Appendix G

Dallas LFMP Ticketing Hall Simulation

Memo

To: Dan Weber, Diego Rincon, Terry Mitchell, Kenneth Gwyn, Cliff York, Wade Ellison
From: Karen Kavanagh
CC: Johnny McKnight, Jamey Tasker, Marty Tasker, Manoj Patel
Date: 5/25/2015
Re: Reduction in Ticket Hall Size - Simulation Results

2.1 Original Three Pod Design

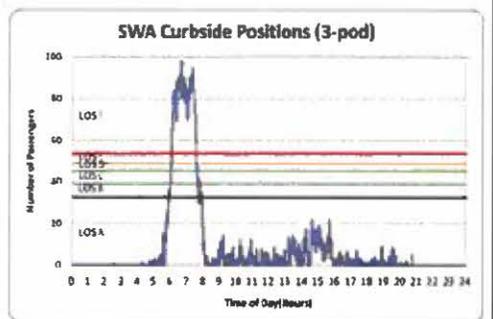
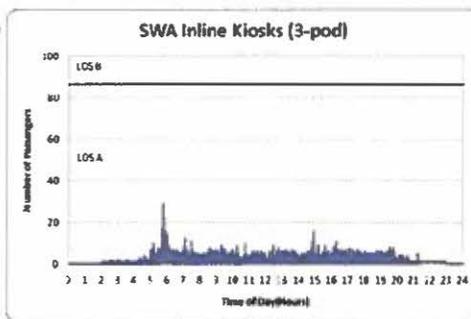
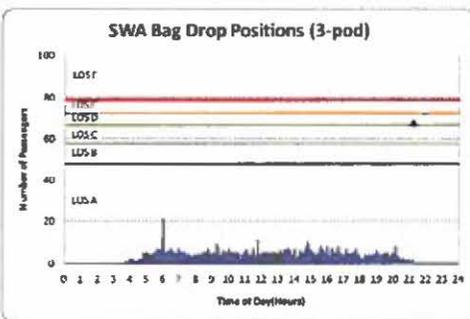
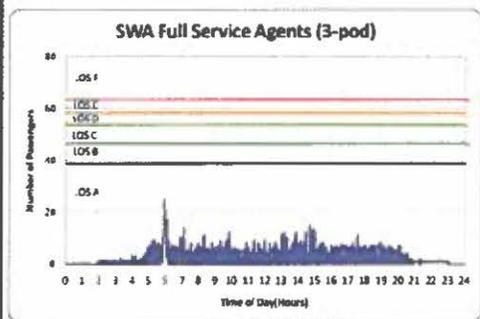
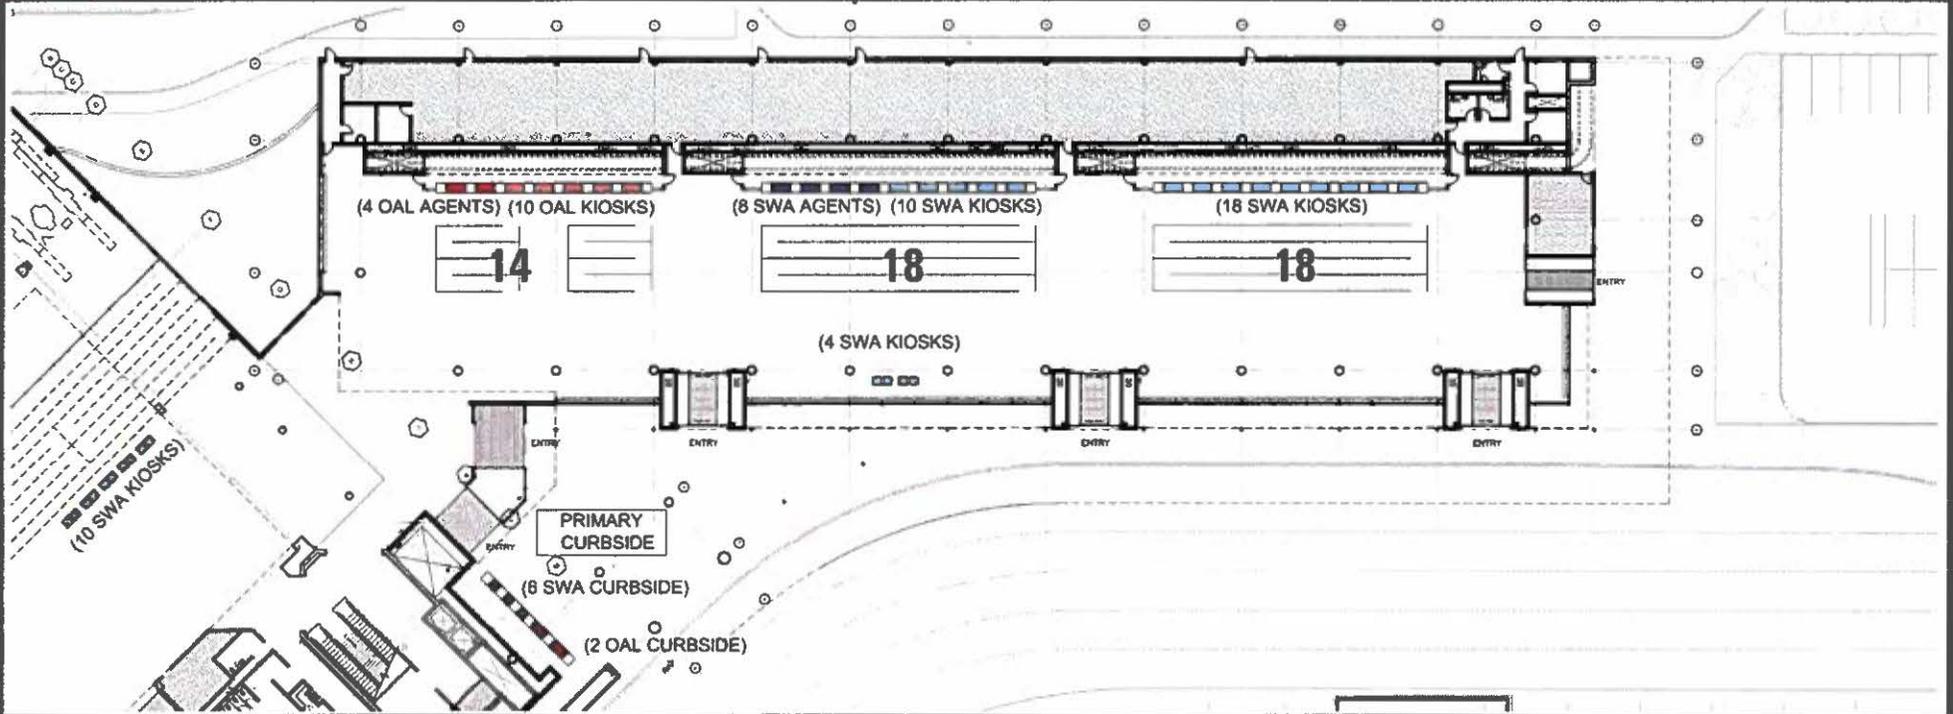
1. Original design based upon TARPS metrics and touch point requirements
2. Not seen as reflective of current industry trends

1. Achieves LOS A at all times in all areas
2. Excellent level of performance based upon numbers of touch points at the belt

3.1 Two Pod (VE Idea)

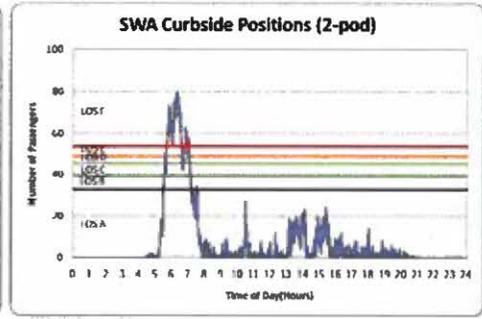
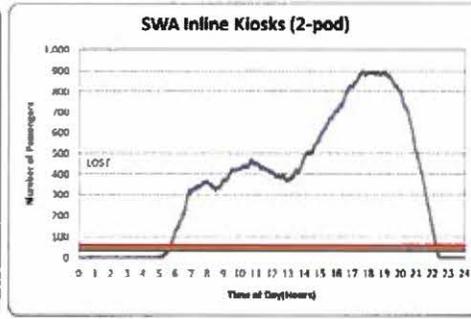
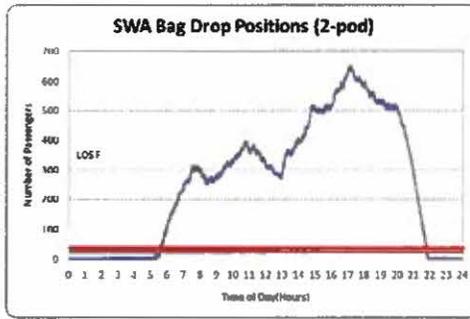
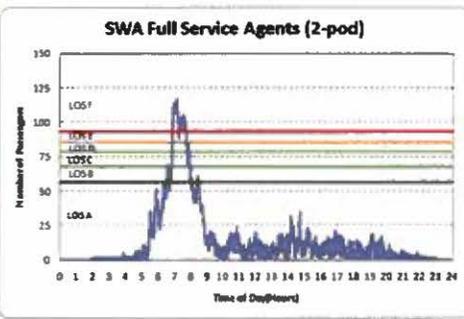
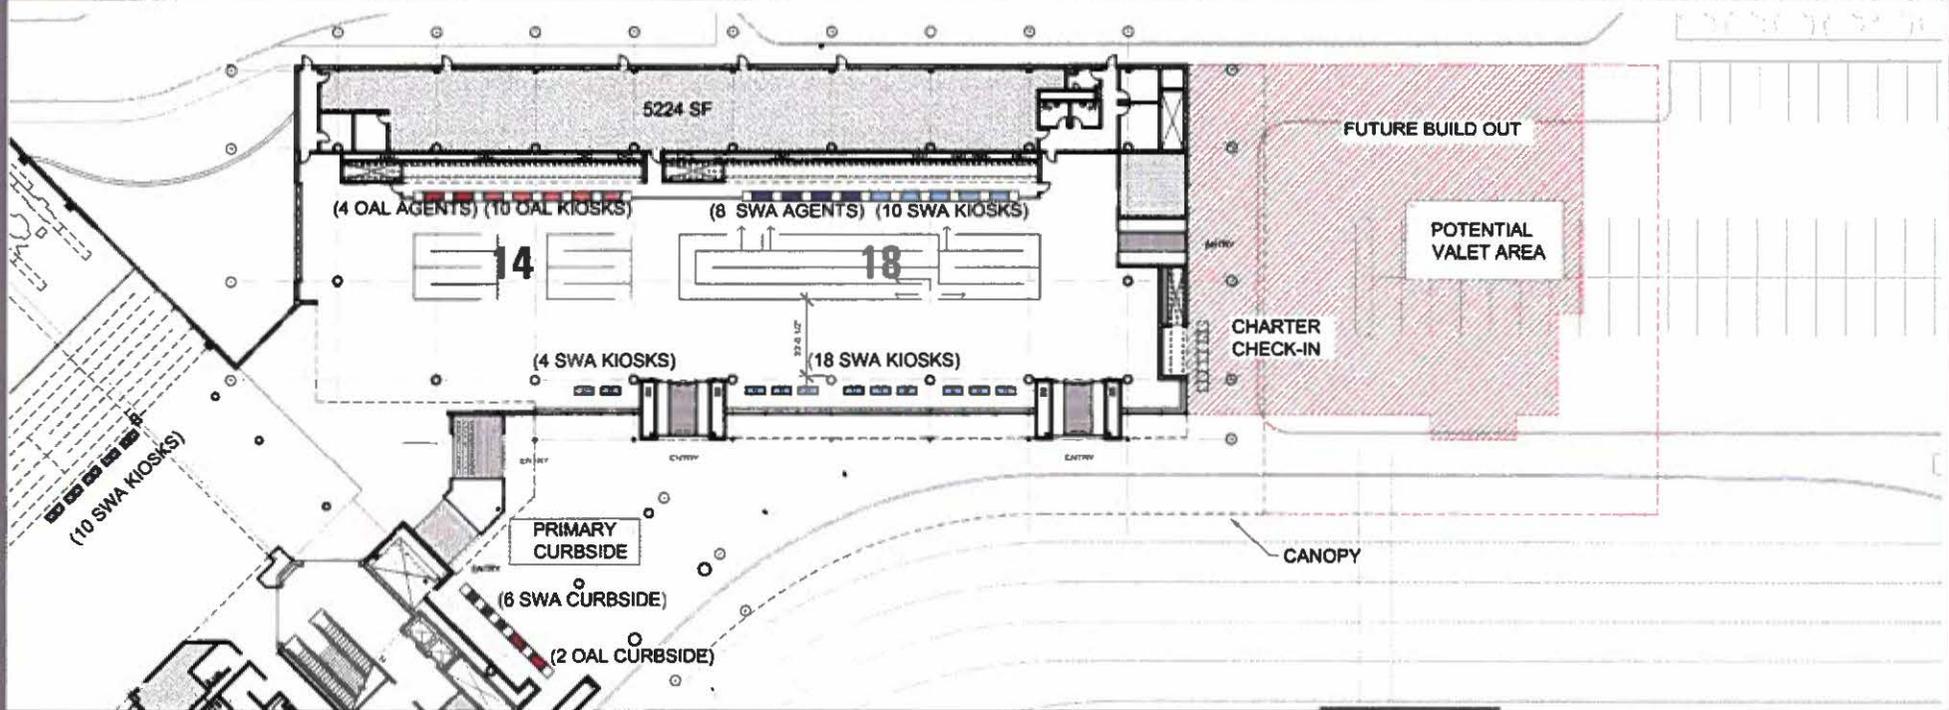
1. Attempt to eliminate one full pod as a cost savings measure
2. Also removed the East tunnel from the lower level roadway
3. Maintained TARPS metrics but shifted balance of kiosk activity away from belt
4. Reduces hall by approximately 27% in size and \$3.5M in cost
5. Reduction in effective curb length but does not exceed acceptable level of service

1. Performs at LOS F at all times in all areas
2. Failure based upon lack of touch points at the belt

4.1 Modified Three Pod

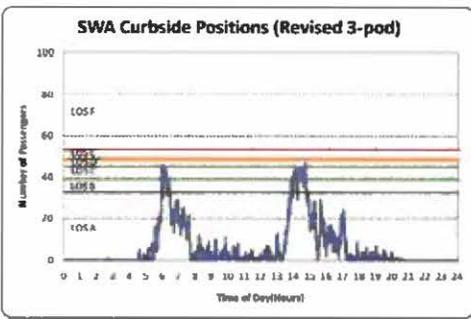
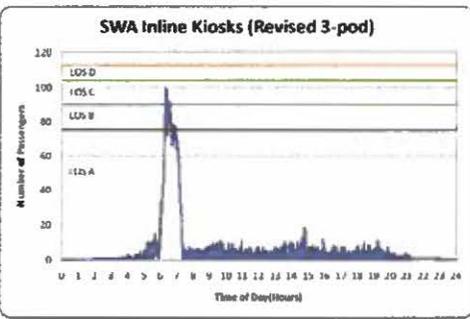
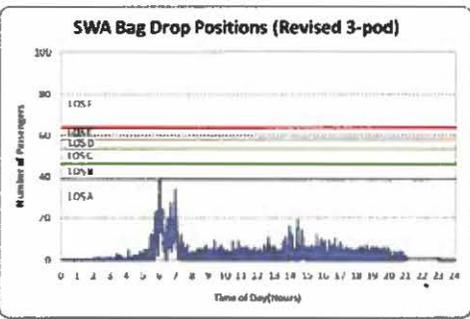
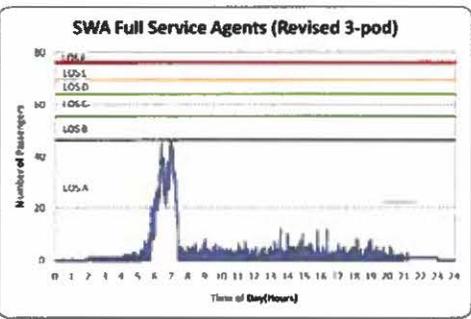
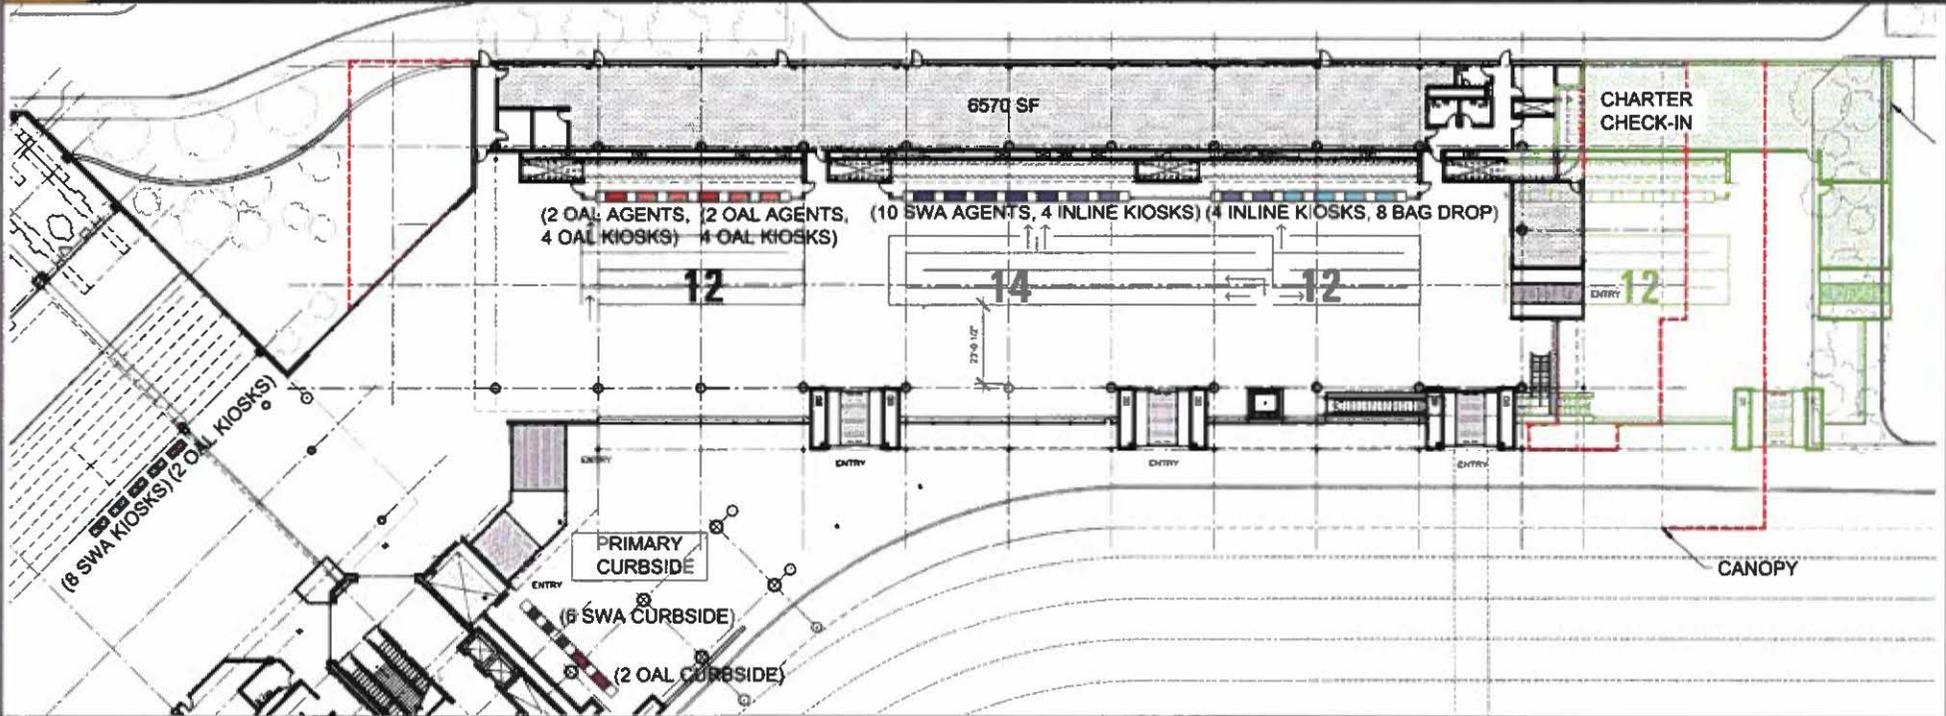
1. Uses modified Full Service and Kiosk processing times provided by SWA, maintains 3 takeaway belts
2. Reduces hall by approximately 15% in size and \$2M in cost
3. Provides for future 4th pod to be added without additional BHS cost or basement construction
4. Minimal reduction in effective curb length with no measurable impact to roadway LOS
5. The location of an additional 16 boarding pass only kiosks is TBD

1. Performs at LOS A with 80% load factor
2. Opening day build-out allows for growth to 85% load factor without reducing LOS past C

1. We recommend adopting the Modified 3 Pod layout as shown on page 4.1
 - a. This layout accommodates the opening day and ultimate flight schedule activity levels at or below LOS C at TARPS load factors
 - b. This concept allows for future expansion of one additional pod (12 positions) with minimal BHS and basement work required
2. We recommend maintaining the East Tunnel access directly into the ticketing hall

Because the PFC Application was approved based on a detailed Significant Contribution which focused on LOS, we informally reviewed this option with FAA Southwest Region. They have agreed to this VE option that reduces the Ticketing Hall by approximately 15% provided the following parameters are met:

- 1. The LOS for the project does not go below a Level of Service (LOS) C throughout the projected life of the program (2024).**
 - a. The simulation of the ticketing hall, after the reduction, showed an overall LOS of A (with the exception of the curbside) with 80% load factors through 2024.

- b. The proposed deferred reduction maintains an overall level of service C with 85% load factors through 2024.
Note: 2024 is the horizon used by the FAA in the significant contribution analysis.

- 3. The project will also need to maintain expansion space of 15% for future growth.**
 - a. This will be labeled as "Demand- driven" expansion on the final drawings.
